## CAIRNGORMS NATIONAL PARK AUTHORITY

**Title: PROPOSED SECTION 36 APPLICATION FOR A HYDRO -  
ELECTRIC GENERATING STATION AT FALLS OF  
UNICH, NEAR LOCH LEE, ANGUS.**

**Prepared by: Norman Brockie, Planning Officer (Local Plan/Policy)**

### DRAFT RESPONSE TO REQUEST FOR SCOPING OPINION THE ELECTRICITY WORKS (ENVIRONMENTAL IMPACT ASSESSMENT) (SCOTLAND) REGULATIONS 2000 **PROPOSED SECTION 36 APPLICATION FOR A HYDRO -ELECTRIC GENERATING STATION AT FALLS OF UNICH, NR LOCH LEE, ANGUS**

Plan of the proposed hydro-scheme with various options.

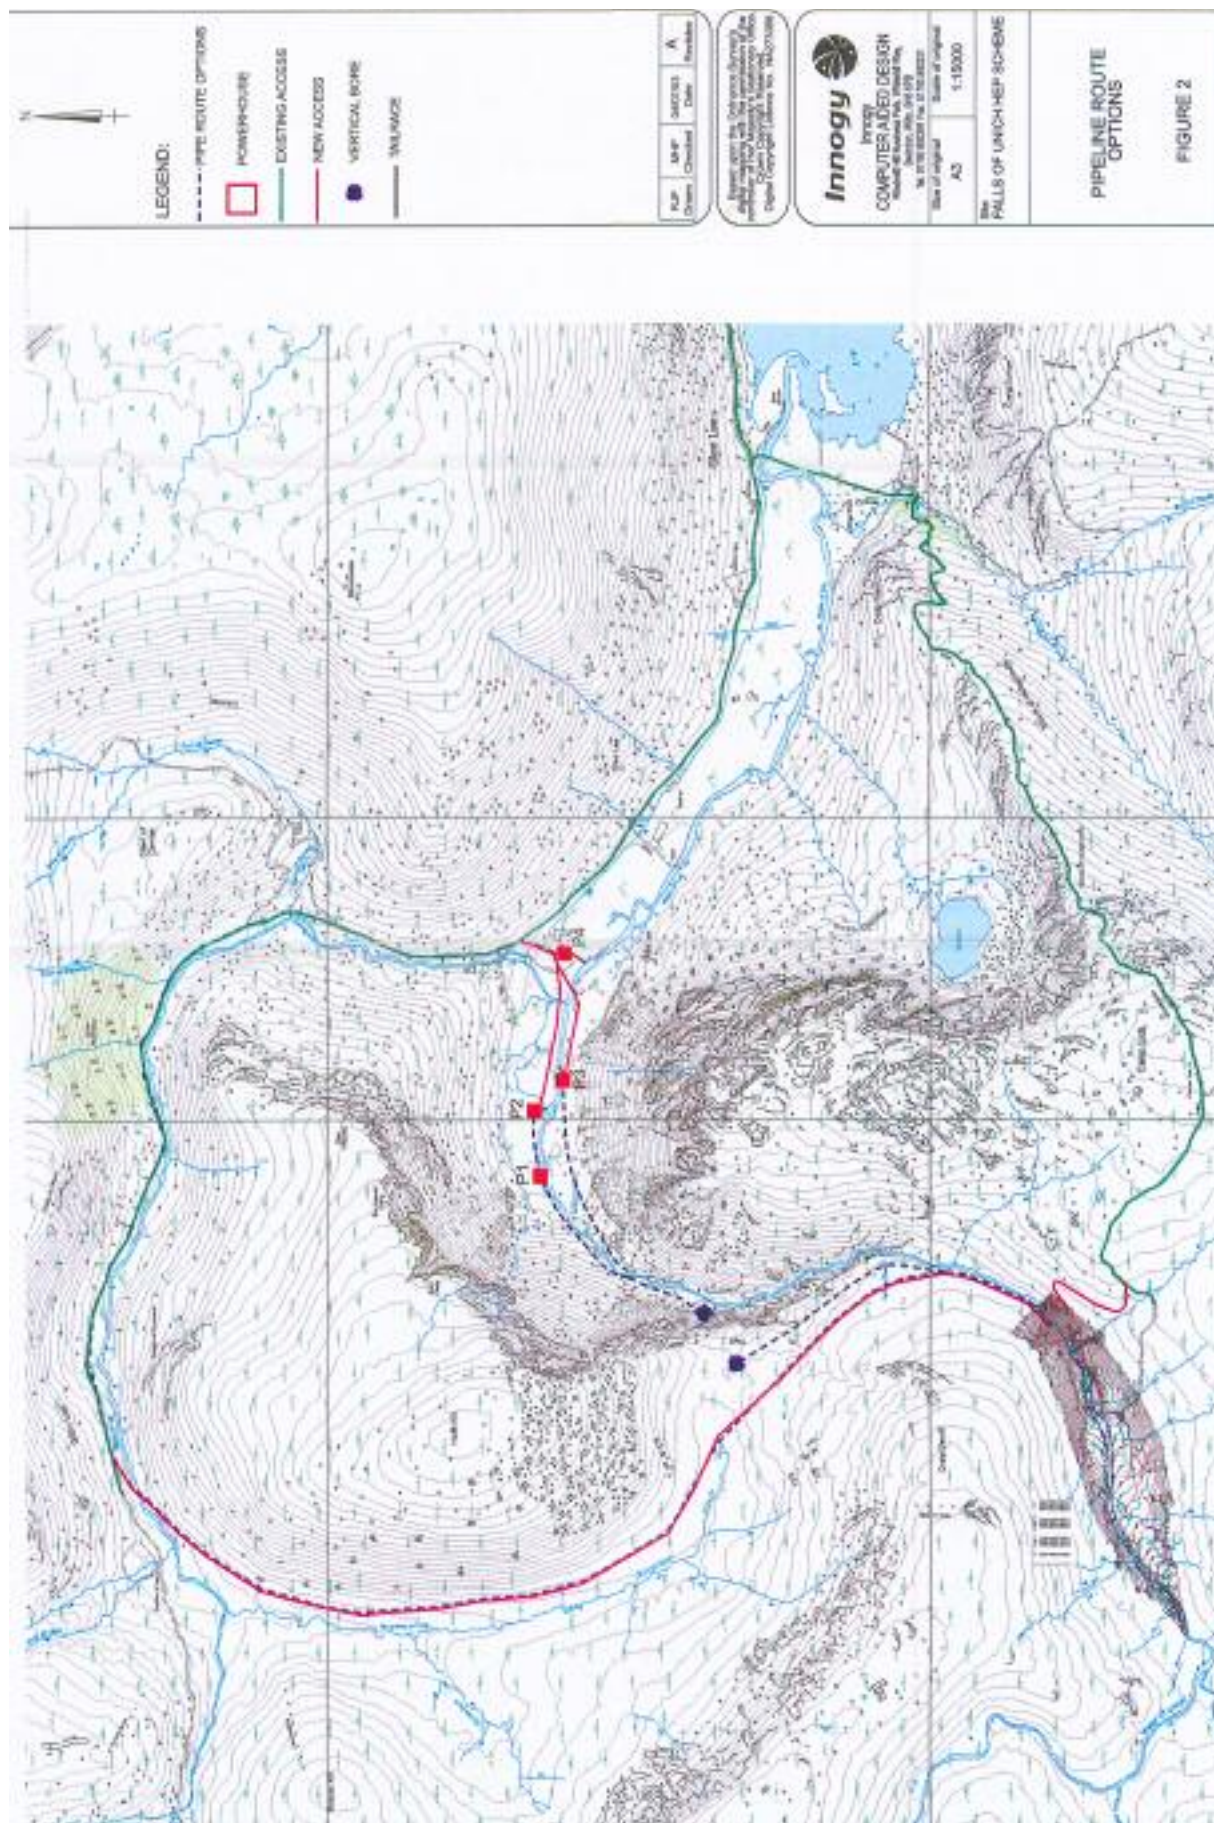
**Access:** If the existing track is to be upgraded (to take construction traffic) then we need to know the extent of this and the proposed materials. Likewise, for the new tracks we need to know the method of construction and materials proposed. New tracks will also need drainage provision, which will have significant environmental impacts (see section 2).

**Dam & Reservoir:** The implications for constructing a 180m (approx) wide dam in such a remote location are immense. A detailed methodology is required for the construction process as well as a list of materials and a comprehensive landscape impact analysis.

**Pipe routes:** On completion, the pipes should not be visible at any point; a detailed methodology is required for the installation, whichever route option is preferred.

**Powerhouse:** The powerhouse, with a footprint of 10x14m, is going to be extremely exposed sitting at the head of the Glen Lee floodplain, where the only existing development is a derelict corrugated-iron shack. Materials should be local stone walling and slate roof (or a turf roof), the building should be designed & built to sustainable standards, and its visual impact should be reduced as much as possible.

**Cable links:** the cable connection to the national grid should be underground for its entire route; details are required for this installation.
